TEXAS DEPARTMENT OF INSURANCE

Proposed Change to Windstorm Building Requirements or Procedures in the Texas Windstorm Insurance Association Plan of Operation

Prescriptive methodology for hurricane resistant residential structures.

Document 2003 International Building Code _____
Section R803.2.3, R803.2.3.1 _____
Table _____
Figure R803.2.3.1 _____
Appendix _____

FIGURE R803.2.3.1
ROOF SHEATHING NAILING ZONES

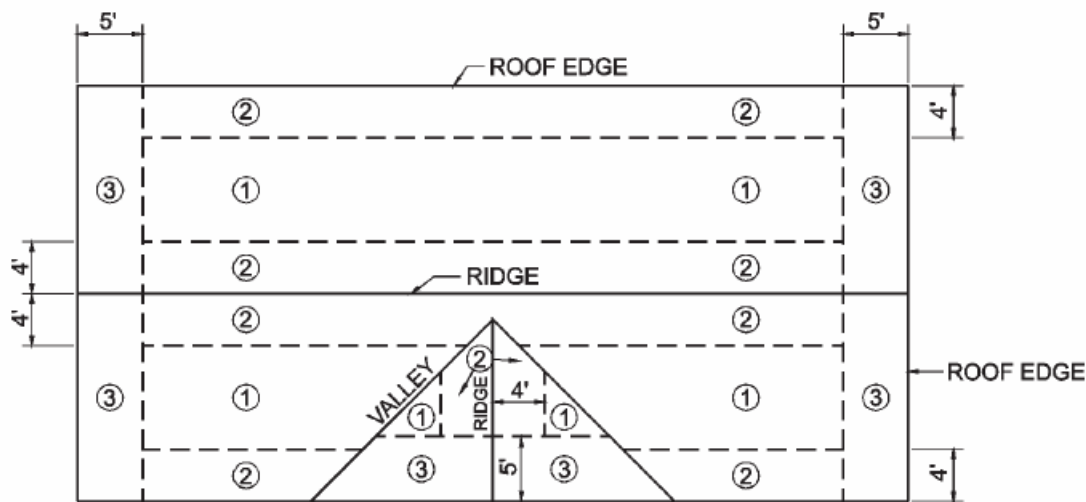
Where roof framing with a specific gravity, $0.42 \leq G < 0.49$ is used, spacing of ring-shank fasteners shall be 4 inches on center in nailing zone 3 for 130 mph or greater design wind speeds in accordance with Figure R803.2.3.1.

1. Where roof framing with a specific gravity, $0.42 \leq G < 0.49$ is used, spacing of ring-shank fasteners shall be permitted at 12 inches on center at intermediate framing in nailing zone 1 for any design wind speed and in nailing zone 2 for 110 mph or lower design wind speeds in accordance with Figure R803.2.3.1.

2. Where roof framing with a specific gravity, $G \geq 0.49$ is used, spacing of ring-shank fasteners shall be permitted at 12 inches on center at intermediate framing in nailing zone 1 for any design wind speed and in nailing zone 2 for 120 mph or lower design wind speeds in accordance with Figure R803.2.3.1.

3. Where roof framing with a specific gravity, $G \geq 0.49$ is used, 8d common or 8d hot dipped galvanized box nails at 6 inches on center at edges and 6 inches on center at intermediate framing shall be permitted for 100 mph or lower design wind speeds in accordance with Figure R803.2.3.1.

Implementing this proposed modification will significantly improve the performance of roofs under the impact of hurricane winds. Reducing the potential for damage to roofs is essential to preserving the integrity of the building envelope. Obtaining a significant improvement in performance and doing so at basically minimal to negligible cost increase, provides a rather generous benefit-cost ratio.

The proposed change is based on a Factor of Safety (FS) of 2.0 for the panel as whole instead of the capacity of individual fasteners. The FS accounts for panel variabilities and adjustments for missing

This shows a 131% improvement in performance when 8d ring shank nails are used instead of the currently prescribed 8d common nails.

These results show that the currently prescribed 8d common nail would only meet allowable design uplift pressures for some limited roof conditions, roof heights, and only up to wind speeds of 120 mph. In contrast these results show that sheathing attached with the proposed 8d ring shank nail would perform adequately under all roof conditions and heights, from 15 feet up to 40 feet, including gable ends in any exposure category.

R803.2.3.1 Sheathing fastenings. Wood structural panel sheathing shall be fastened to roof framing with 8d ring-shank nails at 6 inches on center at edges and 6 inches on center at intermediate framing. Ring-shank nails shall have the following minimum dimensions:

1. 0.113 inch nominal shank diameter
2. Ring diameter of 0.012 over shank diameter
3. 16 to 20 rings per inch

- 4. 0.280 inch full round head diameter
- 5. 2 inch nail length
